## **Response to reviewer's comments**

The infrastructure described in this paper is for the physical model only of HadGEM3 (HadGEM3-AO) which will in future be the underpinning model for the Earth System version of the model (HadGEM3-ES). We propose to make this clear in section 1 of a revised manuscript. To make this distinction clearer we could use HadGEM3-AO throughout (a naming convention consistent with HadGEM2).

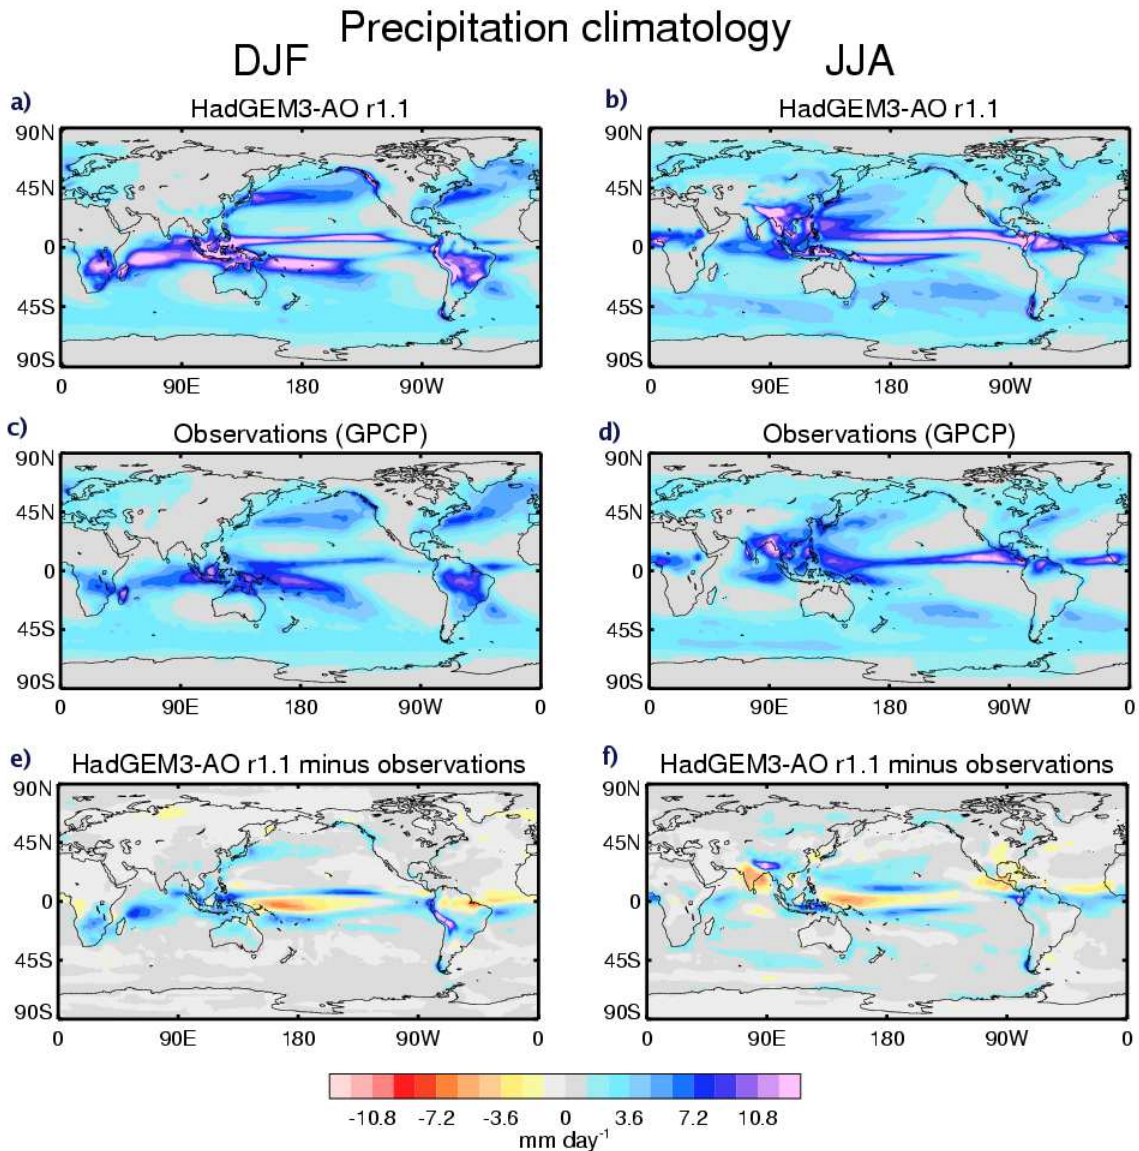
- Fig 7f is wrong and looks like a copy of 7e. Also how long is the averaging period from the model.  
We thank the reviewer for spotting this. There was an error in the plotting routine which resulted in one of the plots being duplicated. This has been corrected (see

below). The averaging period from the model is 30 years and this information will be added to the plot description.

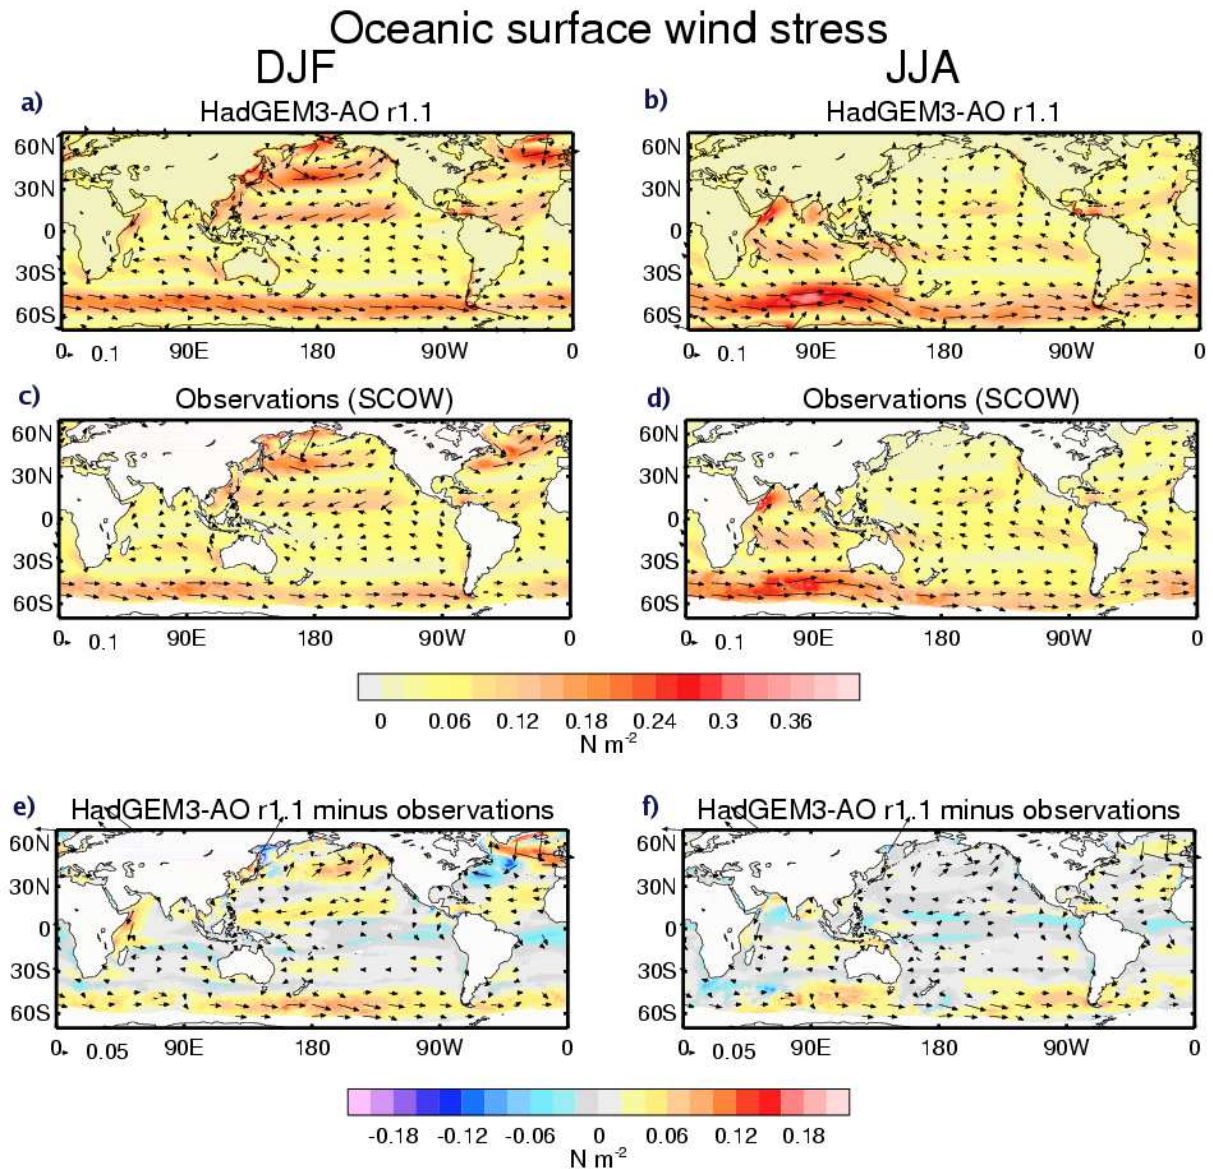
- Given that the paper primarily seeks to validate the coupling it would be more appropriate to show surface stress rather than u850mb.
- P1879L10: This comment would also be more substantiated by showing surface stresses instead of u850mb.

We attach the plot of the oceanic surface wind stresses relative to the Scatterometer Climatology of Ocean Winds (SCOW). This plot shows similar biases to the 850hPa wind biases although the biases on the equator have reduced and the biases in the Southern Ocean have increased a little. The surface wind stress bias plots are only available over the oceans so these plots contain less information than the 850hPa wind plots.

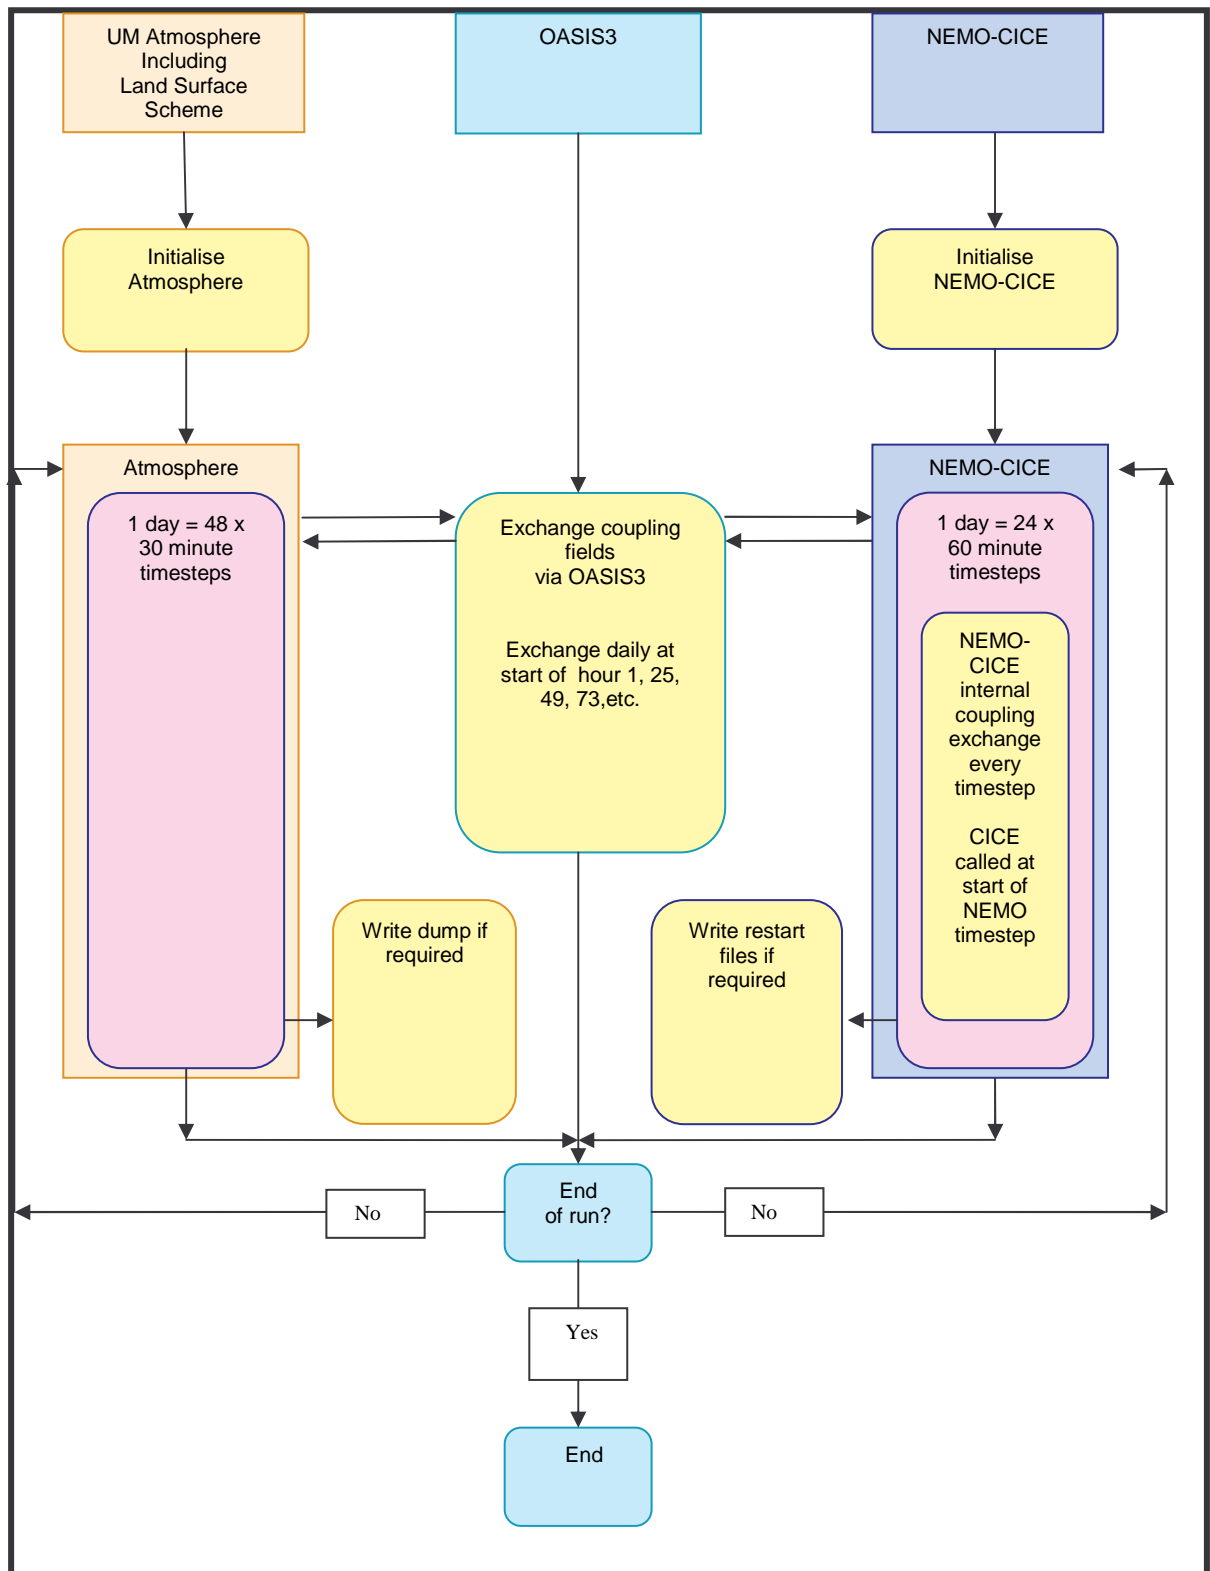
7. It would be useful to show a schematic clearly illustrating the time-stepping arrangement, with time axis along the page and showing the timing of the ocean, sea ice and atmospheric steps and the coupling times.

We do not think an extra figure is required but propose to modify Figure 3 (attached below) slightly to make the timing of coupling exchanges slightly clearer, and to complement the information already in section 3 and figures 4 and 5.
